Modification of Minister's Approval

Section 75W of the *Environmental Planning & Assessment Act 1979*

Application Number:	MP10_0076
Proponent:	Sutherland & Associates
The Authority:	Minister for Planning
The Land:	Kirrawee Brick Pit, 566-594 Princes Highway, Kirrawee
Concept Approval:	Kirrawee Brick Pit Concept Plan granted on 23 August 2012 by the Planning Assessment Commission
Project:	Mixed use retail/commercial and residential development and associated public open space
Modification:	<p>MP 10_0076 MOD 3: modification includes:</p> <ul style="list-style-type: none">• 24,265m² increase of GFA (from 60,735m² to 85,000m²), comprising:<ul style="list-style-type: none">• 69,310m² of residential;• 14,190m² of retail/commercial (including 4,740m² supermarket and 1,450m² discount supermarket); and• 1,500m² community facility.• reduction of the total number of building envelopes from nine to seven and reconfiguration and amendment of building envelope locations, footprints, heights, separation distances and setbacks;• amended construction staging and timing of the delivery of the open space; and• removal of the car parking cap and imposition of car parking rates.

The Concept Plan for

Rev.	Date	Approved by	Revision Notes	Project No.	13040	Drawn by	CH	North
Scale	1:500, 1:1500 @A1, 50% @A3			Dwg No.	A-SK-700-001	Rev	M	
Status	For Information

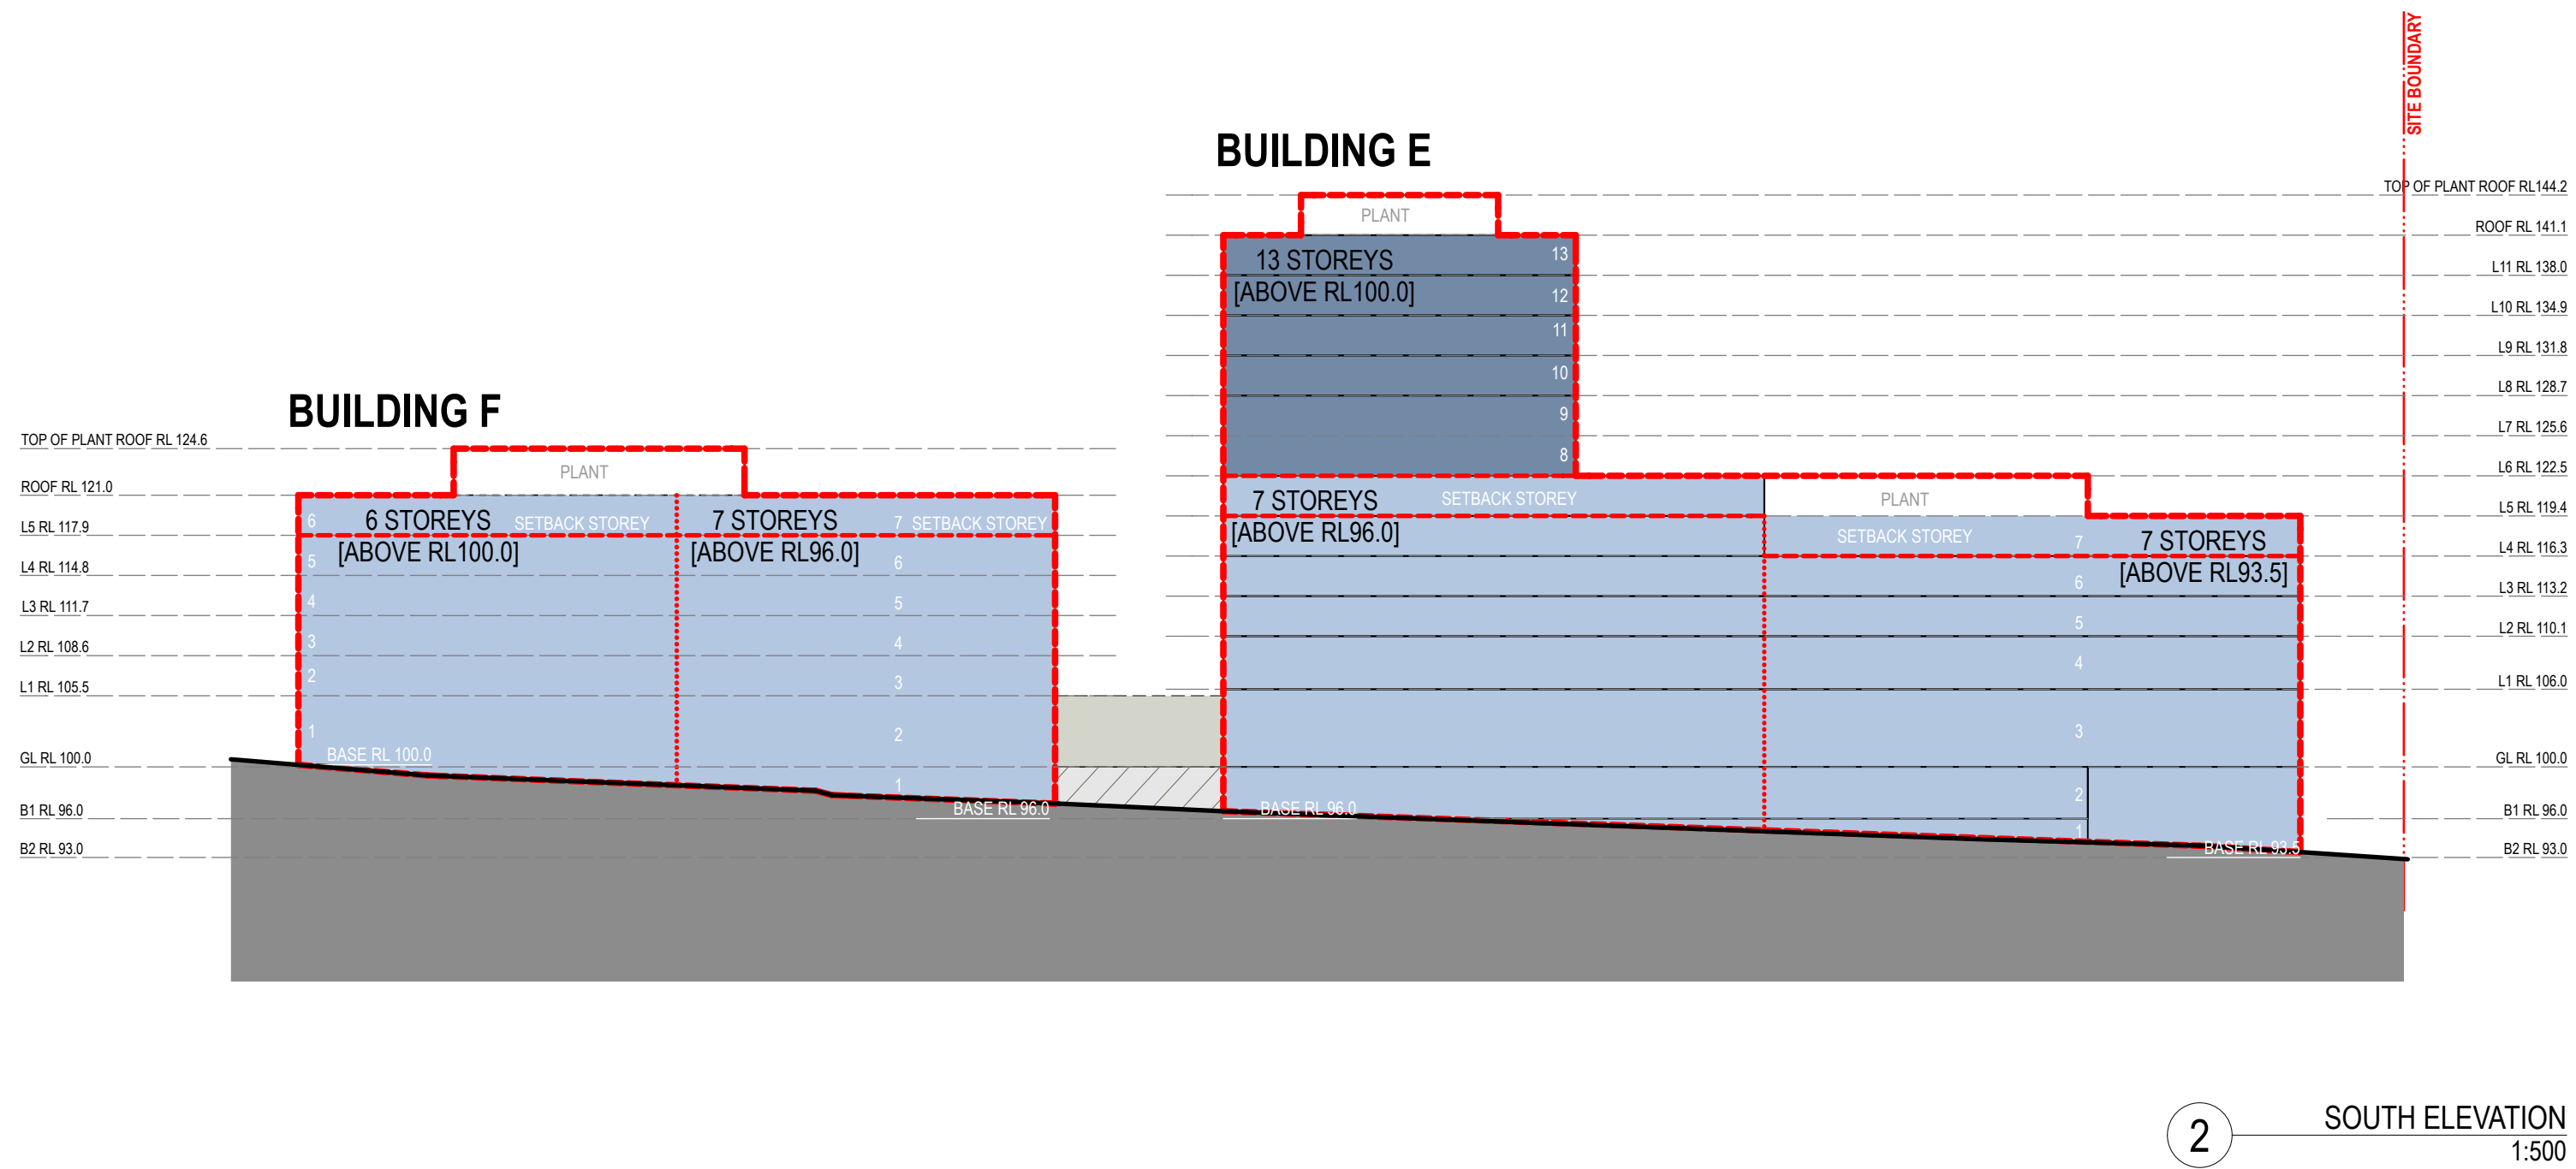
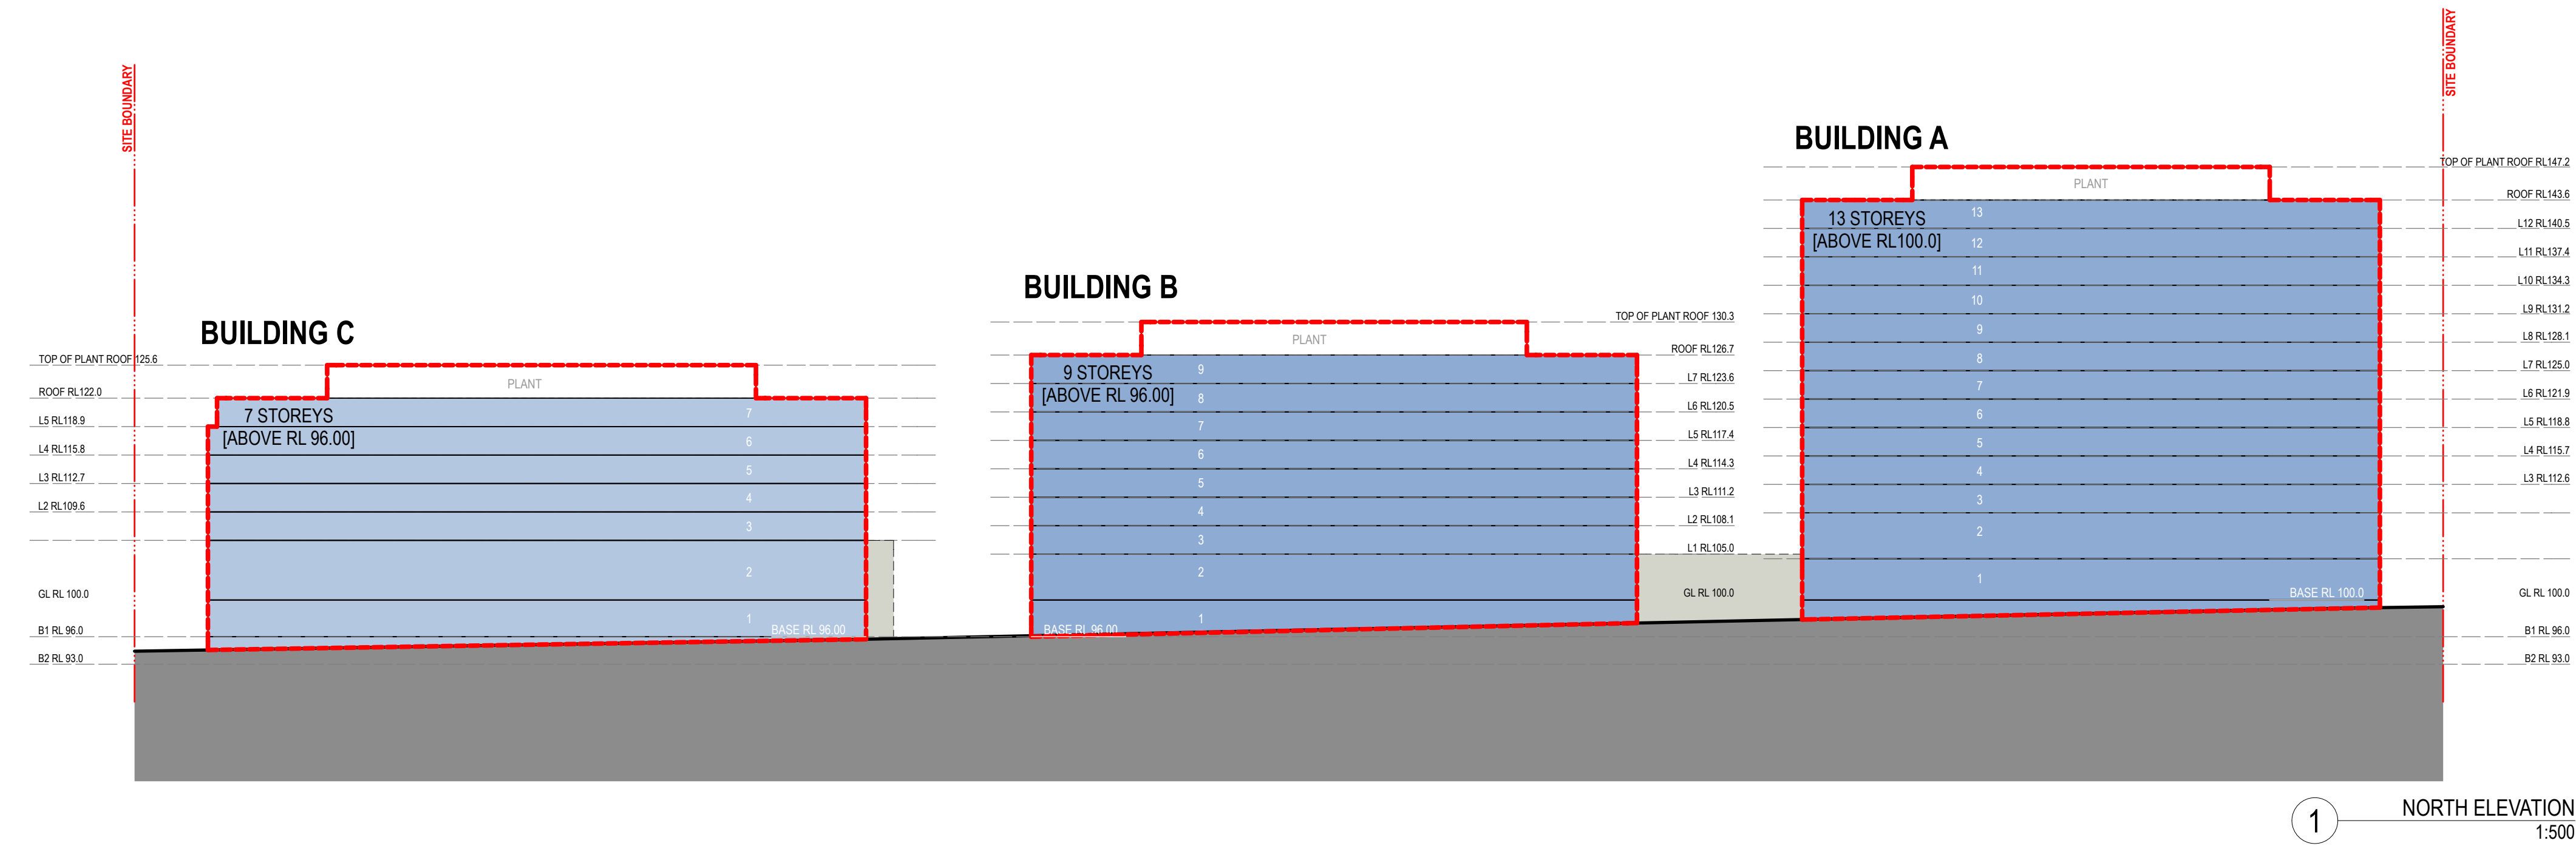
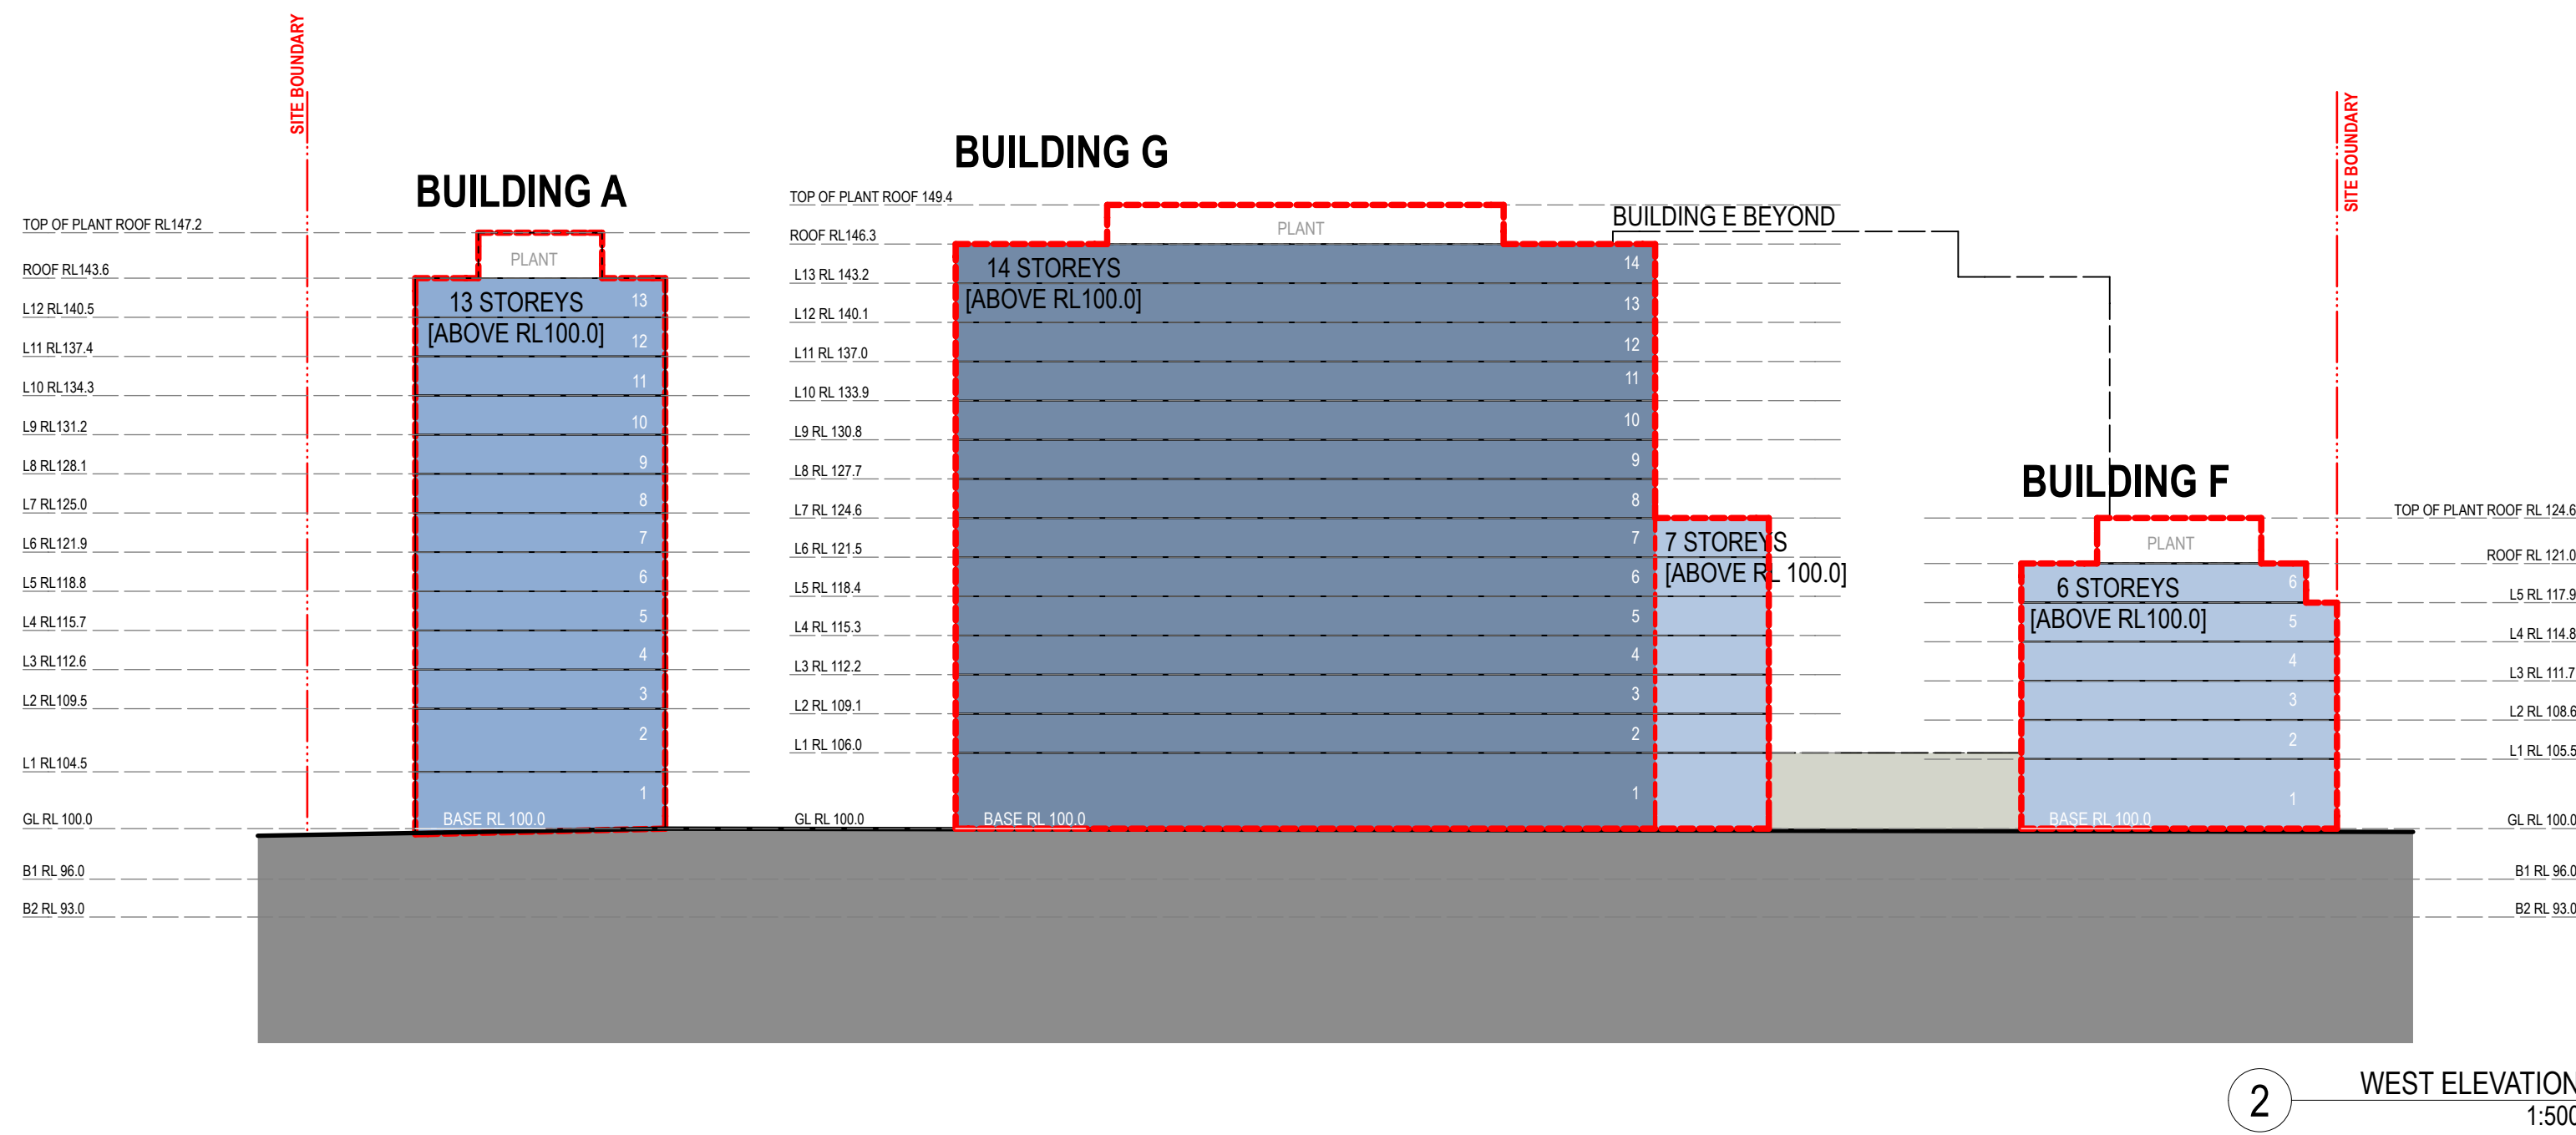
New roadworks and internal roads are to be provided in accordance with the Concept Plan, and associated documents, set out in Drawings ~~0040 & 0130~~ **A-SK-700-001** prepared by **Woodhead Turner Architects**, ~~23 September 2014~~ **19 October 2014** ~~and the Traffic Management and Accessibility Plan prepared by Halcrow Pacific Pty Ltd dated 27 October 2011 (Version 4)~~, and as amended by the Future Assessment Requirements in Schedule 3.
